DEVELOPMENT SERVICES

1329 NE Brandywine Rd - LSMP 64064

PAGE 3 PLAN: AR-1 & 3

THE WALKER

BASEMENT SCALE: 1/4" = 1'-0"

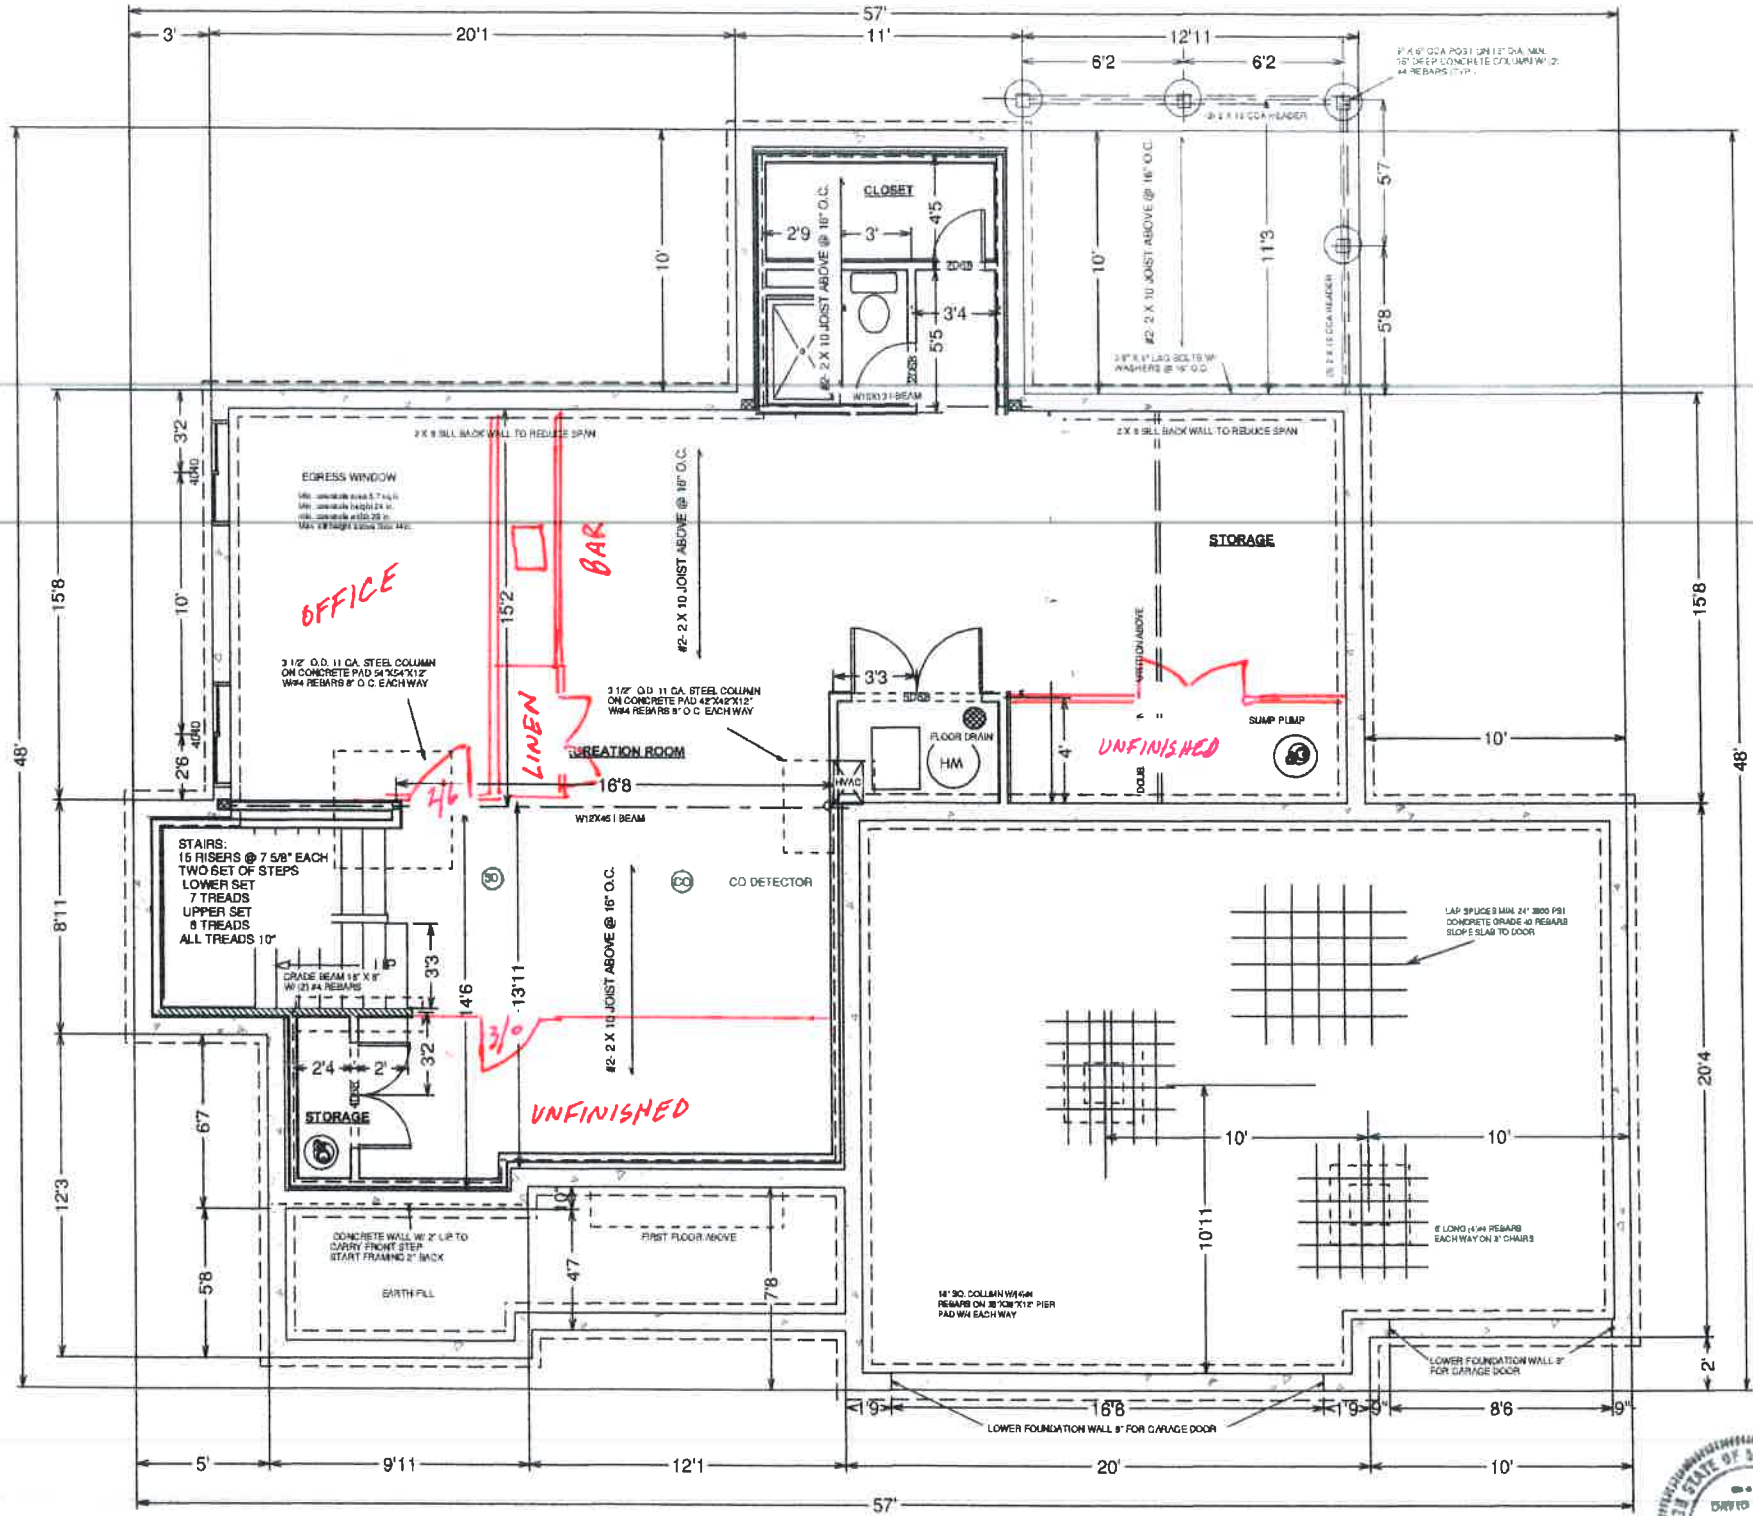
Combustion Air Calculations

Area where furnace & HW heater are located is 28 sq ft

Input Capacities
Furnace = 200,000 BTU/hr
HW Heater = 50,000 BTU/hr
Total = 250,000 BTU/hr

50 cu ft volume required per 1,000 BTU/hr
Volume required = $250 \times 250 = 12,500$ cu ft
Available volume = $28 \times 8 = 224$ cu ft

Normal infiltration is not adequate

Therefore install 2 vents with minimum free area of 150 sq in each (Metal vents with minimum gross area of 200 sq in each) in wall between furnace area and recreation/living area. One opening shall be within 12" of the top and one with 12" of the bottom of the space.
